**Information technology —
Telecommunications and information
exchange between systems — Local
and metropolitan area networks —
Specific requirements —**

**Part 11:
Wireless LAN medium access control
(MAC) and physical layer (PHY)
specifications**

AMENDMENT 1: Fast initial link setup

This amendment defines mechanisms that provide IEEE 802.11 networks with fast initial link setup methods that do not degrade the security offered by Robust Security Network Association (RSNA) already defined in IEEE Std 802.11.

Figure 11-4a—Active scanning by a non-DMG STA with a probe request addressed to an individual address

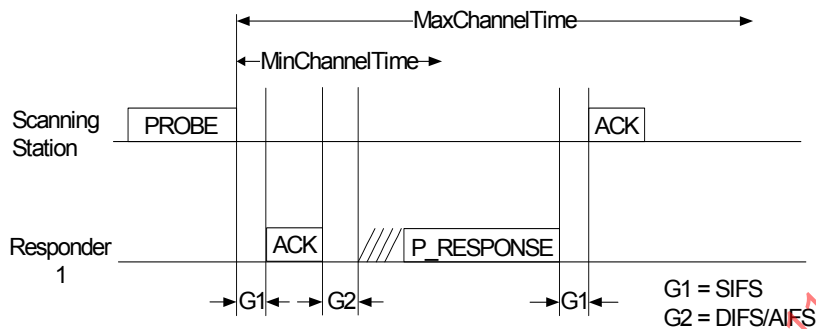
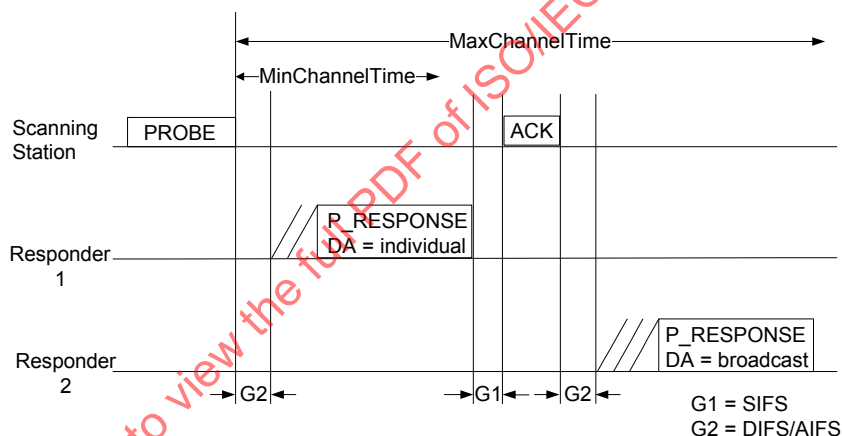
Delete Figure 11-4.

Insert two new figures, Figure 11-4a and Figure 11-4b as follows:

Figure 11-13—Relationship between state and services between a given pair of nonmesh STAs

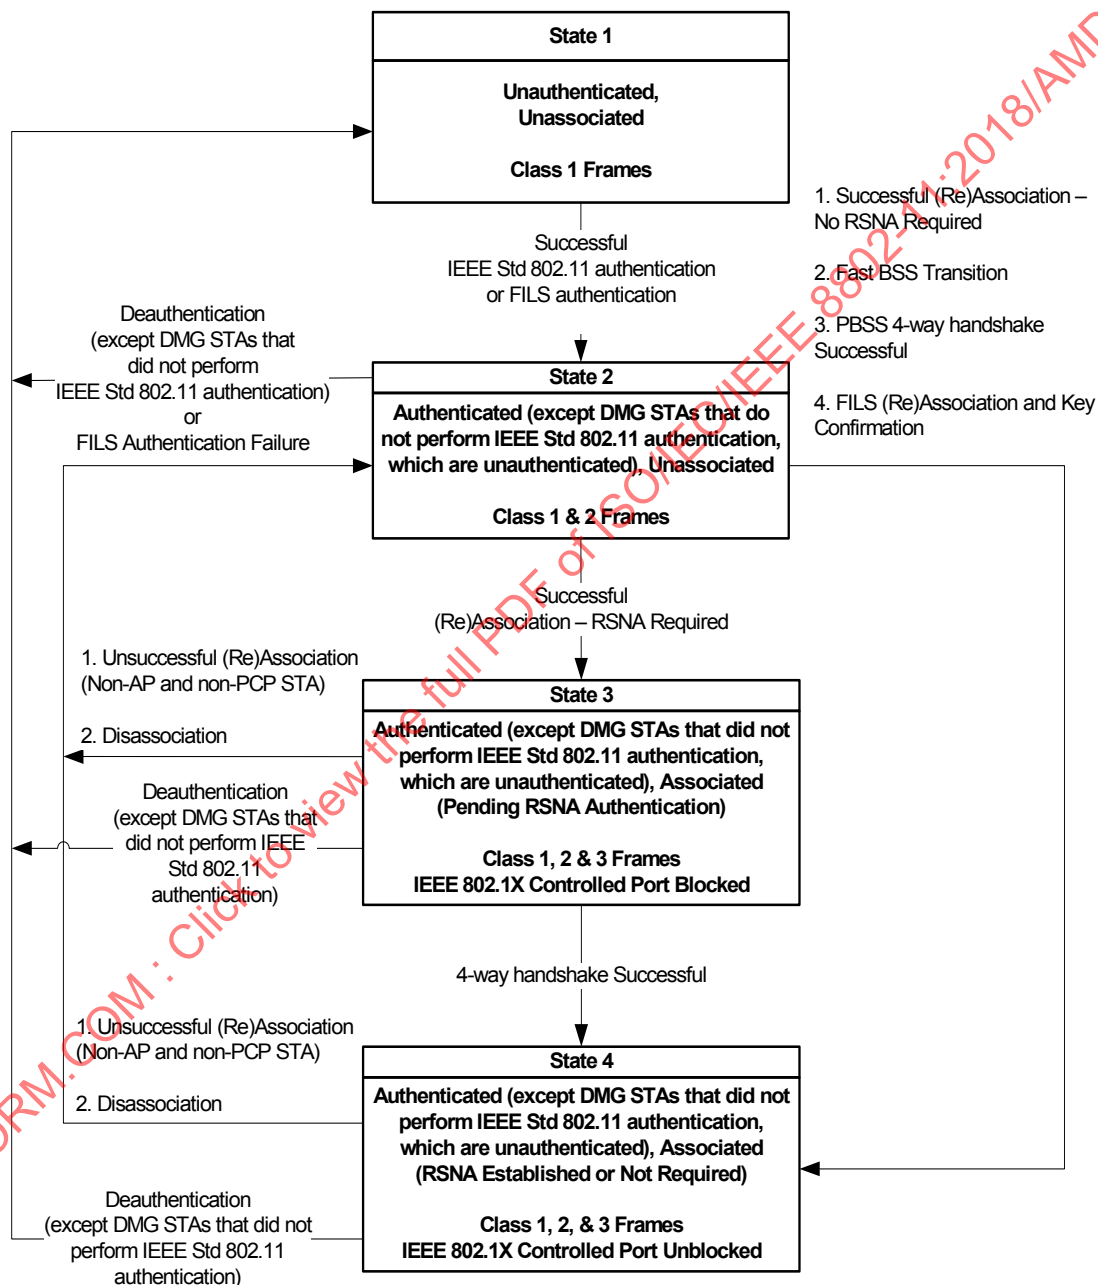
Replace Figure 11-13 with the following:

Figure 12-31—FT key hierarchy at an Authenticator

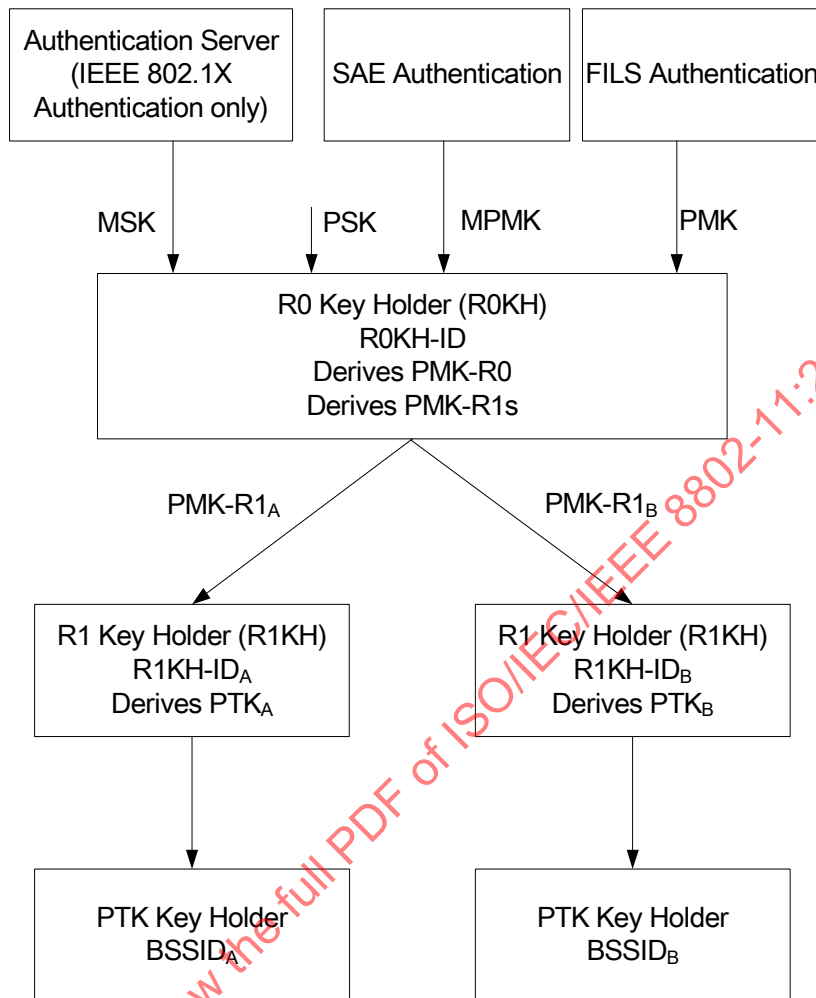
As shown in Figure 12-31, the R0KH computes the PMK-R0 from the key obtained from SAE authentication (for the purposes of FT this key is identified as the Master PMK, or MPMK), from the PSK, ~~or~~ from the MSK resulting (per IETF RFC 3748 [B41]) from a successful IEEE 802.1X authentication between the AS and the Supplicant, or from the PMK (see 12.12.2.5.2) resulting from a successful FILS authentication. Upon a successful authentication, the R0KH shall delete any prior PMK-R0 security association for this mobility domain pertaining to this S0KH. The R0KH shall also delete all PMK-R1 security associations derived from that prior PMK-R0 security association. The PMK-R1s are generated by the R0KH and are assumed to be delivered from the R0KH to the R1KHs within the same mobility domain. The PMK-R1s are used for PTK generation. Upon receiving a new PMK-R1 for an S0KH, an R1KH deletes the prior PMK-R1 security association and PTKSAs derived from the prior PMK-R1.

Replace Figure 12-31 with the following:
